Date: July 20, 2023

Subject: Response to Comments – Semi-Annual O&M Progress Report #8  
Tyco FTC - Ditch A Interim Action Treatment System  
2700 Industrial Parkway South, Marinette, Wisconsin 54143  
BRTTS #02-38-580694; Site ID (FIN): 64624

Attachment 1 Ditch A System OM&M Plan Sections 4 and 7 – Revised July 2023

**DITCH A DOWNSTREAM SURFACE WATER  
SAMPLING LOCATIONS**

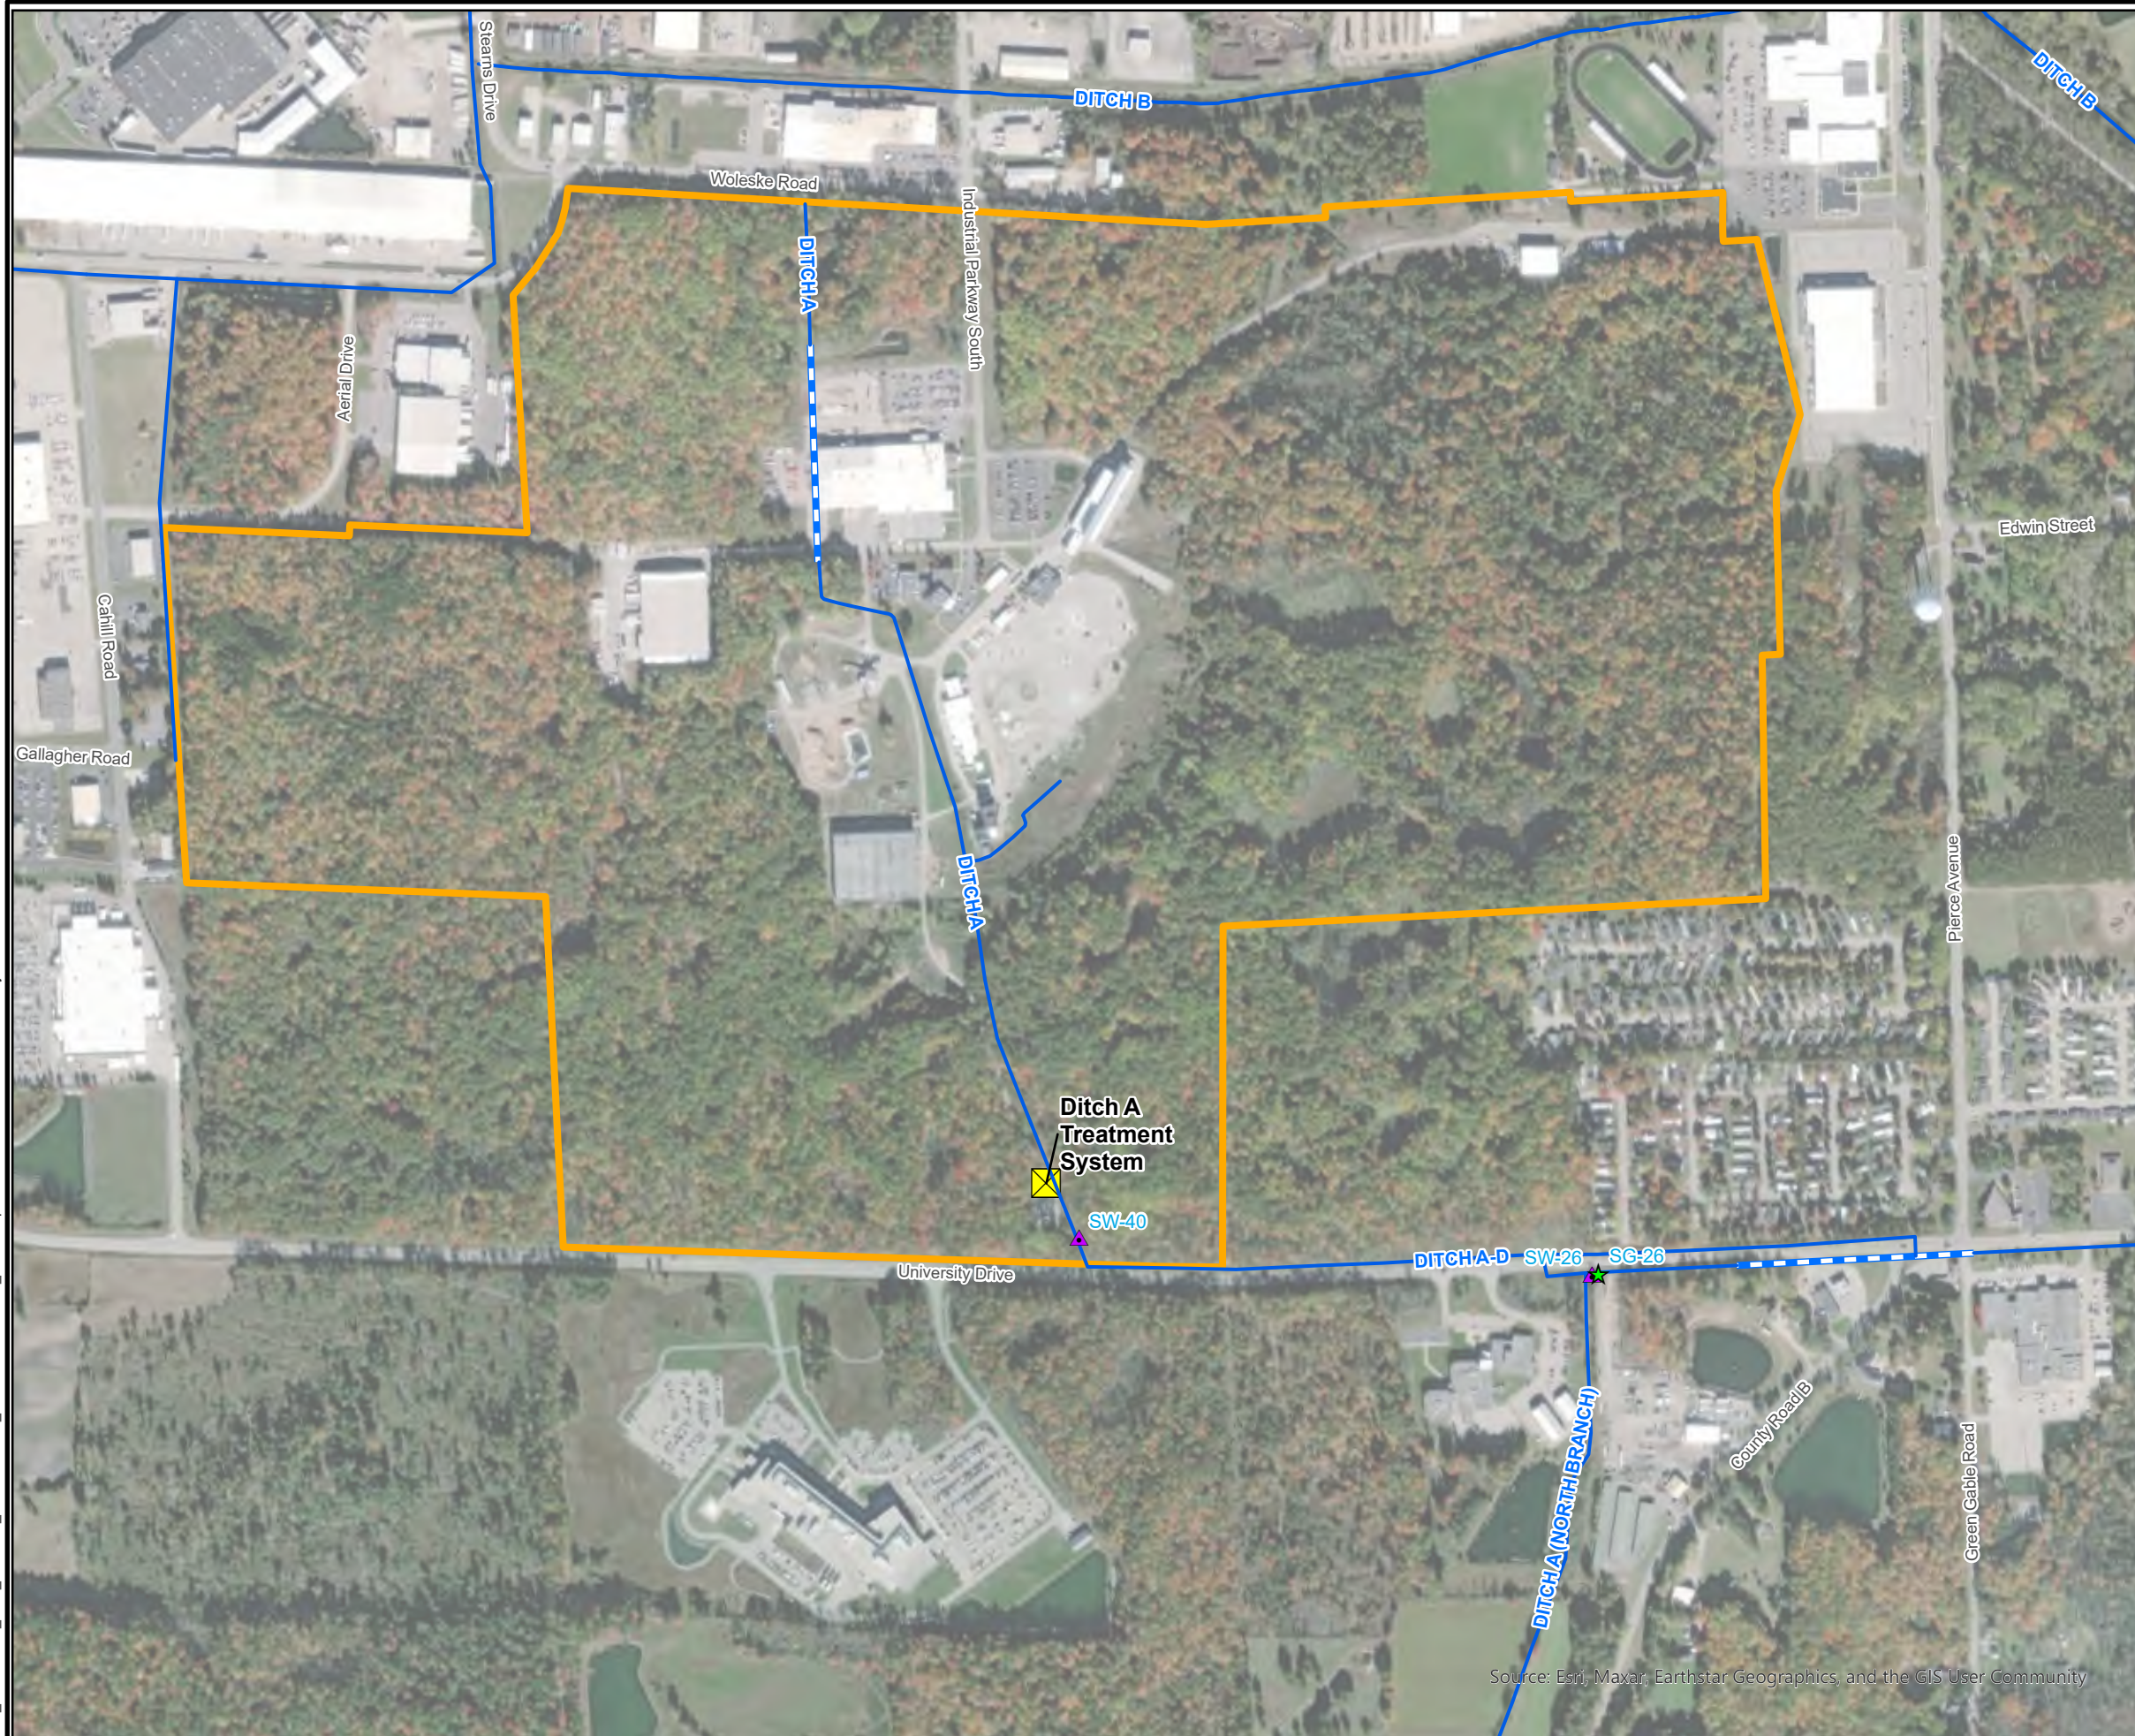
*Per Wis. Admin. Code § NR 724.13(4), the DNR requests that JCI/Tyco update Table 4-1 and Sections 7.5 of the OM&M Plan for Ditch A to improve characterization of PFAS in the surface water downstream of the Ditch A treatment system. This should include, at a minimum, collection of surface water samples at SW-26 concurrent with the monthly sampling at SW-40. Please submit the updated Sections of the OM&M plan to the DNR within 45 days of date of this letter and begin implementing these changes to the long-term surface water monitoring program for Ditch A. (If JCI/Tyco includes the recommendations presented herein, then a fee for additional DNR review and response is not required).*

*Because the concentrations of PFOA and PFOS in the surface water in Ditch A on the FTC property remain above the Wis. Admin. Code § NR 102.04 surface water standards, the DNR recommends that JCI/Tyco continue to operate an interim remedial action to remove PFAS from the surface water. If the PFAS concentrations at SW-26 are found to be greater than the Wis. Admin. Code § NR 102.04 surface water standards during operation of the Ditch A treatment system, then JCI/Tyco must evaluate and report on the cause and significance per Wis. Admin. Code § NR 724.17(3m)(f) and may need to evaluate if modification or additional interim actions are needed.*

Tyco will collect monthly surface water samples from sample locations SW-26 and SW-40 during open water season (defined as observable flow in Ditch A as well as Ditch A System operation) as described in the revised Operations, Maintenance, and Monitoring (OM&M) Plan Sections 4 and 7, included as Attachment 1. Tyco does not intend to collect surface water samples from stagnant water. Sample collection at SW-26 will begin in August 2023 and the corresponding data and field observations will be included in O&M Progress Report #10 (July 1, 2023 – December 31, 2023 reporting period).

The Ditch A downstream surface water sampling locations (SW-40 and SW-26) are shown on **Figure 4**. SW-40 is located immediately downstream of the Ditch A system outfall. SW-26 is located downstream of SW-40 along the south side of University Drive. At the time of sample collection at SW-26, flow conditions in Ditch A north, south, east, and west of SW-26 will be noted along with the water depth reading from the adjacent staff gauge (SG-26) and the Ditch A system operational status (on/off). At a minimum, the following replicates and QA/QC samples will be collected from the downstream sampling locations per Wis. Admin Code § NR 716.13(c)
